LIC-16-0044
June 9, 2016

Fort Calhoun Station (FCS), Unit 1
Renewed Facility Operating License No. DPR-40
NRC Docket No. 50-285

Subject: Response to NRC Request for Additional Information Re: Revise Current Licensing Basis to Use American Concrete Institute Ultimate Strength Requirements (CAC NO. MF6676)

**REQUEST FOR ADDITIONAL INFORMATION
LICENSE AMENDMENT REQUEST
OMAHA PUBLIC POWER DISTRICT
FORT CALHOUN STATION. UNIT NO. 1
DOCKET NO. 50-285**

Figure 1 – Strain Distribution in a Section at Ultimate State

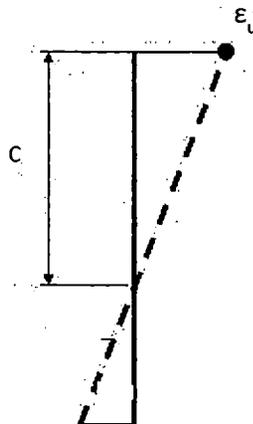
- i. Please provide information related to ductility of the RC&C walls and reconciliation of reinforcing steel detailing requirements of ACI 349-97.**
- ii. The LAR does not discuss/justify an appropriate acceptance criterion/limit for the rotational capacity of yield (plastic) hinge. Please clarify.**
- iii. Partial adoption of a more up-to-date code (ACI 349) is not consistent with the industry practice. Please provide justification.**

Per Figure 1, curvature Ψ_u at the ultimate strength of a section is,

$$r_u = \Psi_u D_h$$

Where D_h is the length of the yield zone which can be determined from output of the finite element software. Rotations at critical sections of the RC&C walls must be less than r_u for the sections to preclude concrete failure.

Figure 2 - Schematic of Step-Wise Linear Analysis Procedure

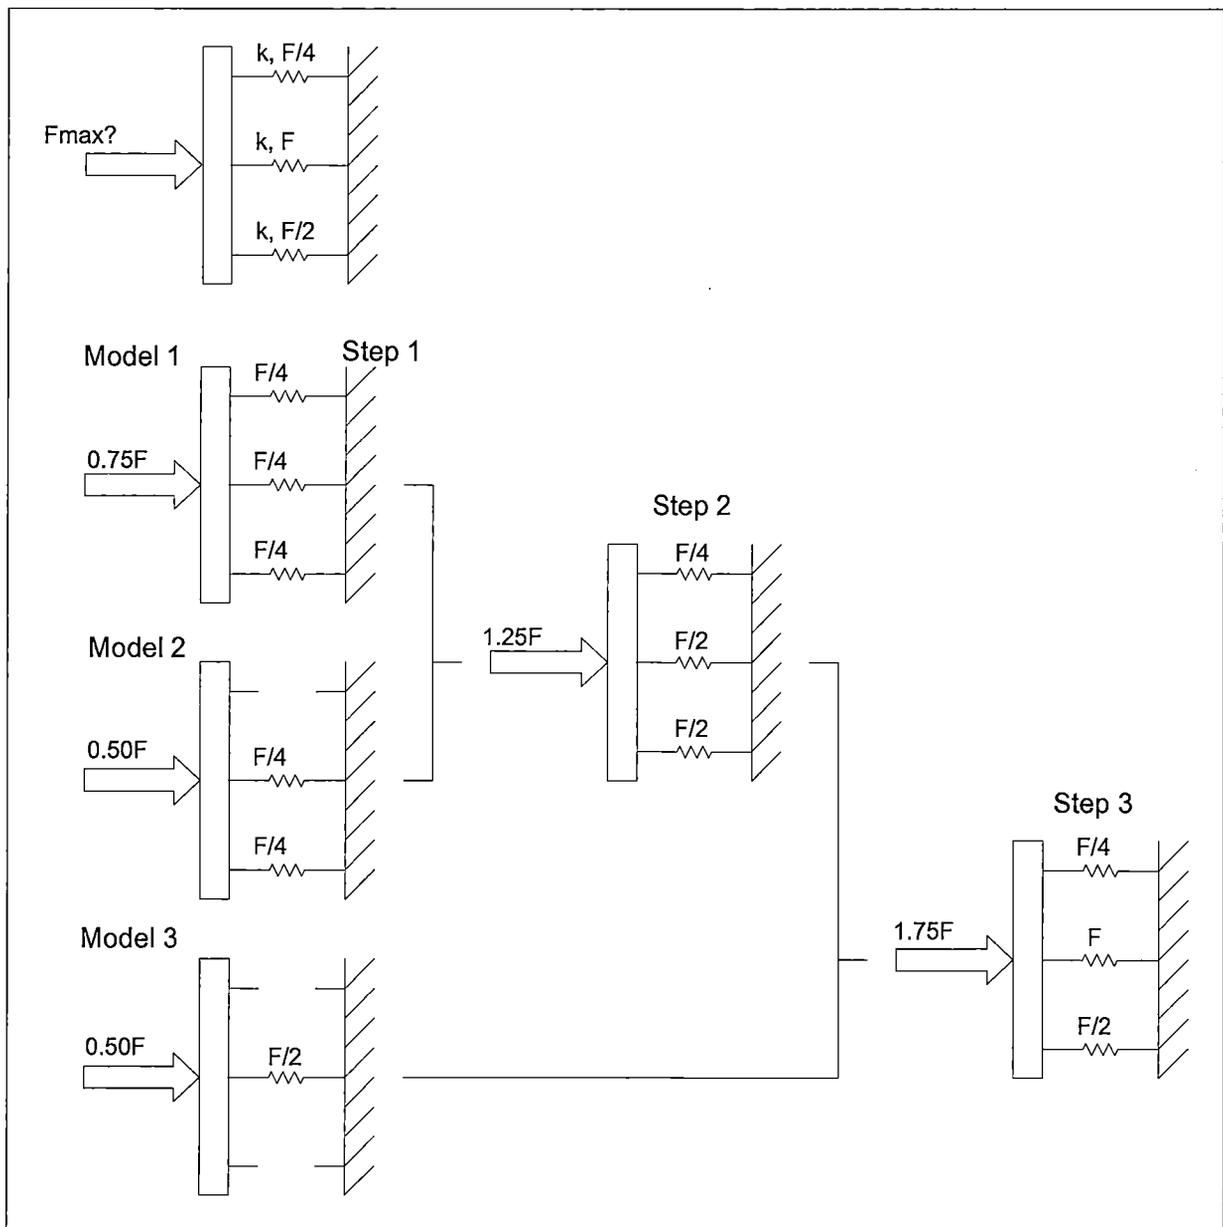
- c. It is the NRC staff's understanding that finite element analysis is used for the RC&C walls structural re-evaluation. Please provide a discussion relative to the application of the limit state design methodology as it relates to the RC&C walls and the applicable load combinations. The response should, as a minimum, include the description of (1) RC&C finite element model/analysis (element type, stress-strain relationship of concrete and reinforcing steel, type of nonlinearity associated with the RC&C wall analysis, incremental and iterative procedures used in the analysis, computer software, benchmarking and model validation, etc.); and (2) how the transverse shear forces and twisting moments, in addition to bending moments, are taken into account.**

The Reactor Cavity & Compartment (RC&C) walls at the Fort Calhoun Station (FCS) will be analyzed using a linear finite element model with a step-wise linear analysis procedure. The procedure is illustrated using the simple example shown in Figure 2. The top of the figure shows a structure consisting of three springs in parallel. For convenience, the springs' stiffnesses are assumed equal, but they vary in strength from $F/4$ to F . Model 1 consists of all three springs. In Step 1, the model is loaded until the strength of the weakest spring (top spring) is reached. This would be the end of a linear analysis, achieving a capacity of $0.75F$. The nonlinear analysis proceeds by removing the top spring and applying a load increment until the residual capacity of the next weakest spring (the bottom spring) is reached (see Model 2). At the end of Step 2, both the top and bottom spring have reached their maximum strength and a load of $1.25F$ has been applied. Implicit is the assumption that the top spring has sufficient ductility to maintain the $F/4$ load through the additional displacement. The analysis continues by removing the lower spring (Model 3) and applying another load increment required to use up the residual strength of the strongest (middle) spring. At the end of Step 3, all three springs are at their maximum strength and a load of $1.75F$ has been achieved. This method is called Limit Design Method (LDM), which is similar to the Yield Line Theory widely used for slabs in industry.

The RC&C walls are modeled using the finite element model (FEM). The elements are organized into groups, each of which has same rebar design and same wall thickness in the same wall plane. When elements reach their capacities, their stiffnesses are set to a small number and the analysis proceeds to the next step. In general, each group of elements is loaded primarily in one direction. The use of the step-wise linear analysis procedure allows the stiffness in the direction of rebar yielding to be set to a small value at the end of an analysis step; the other direction may continue to take load as the analysis proceeds.
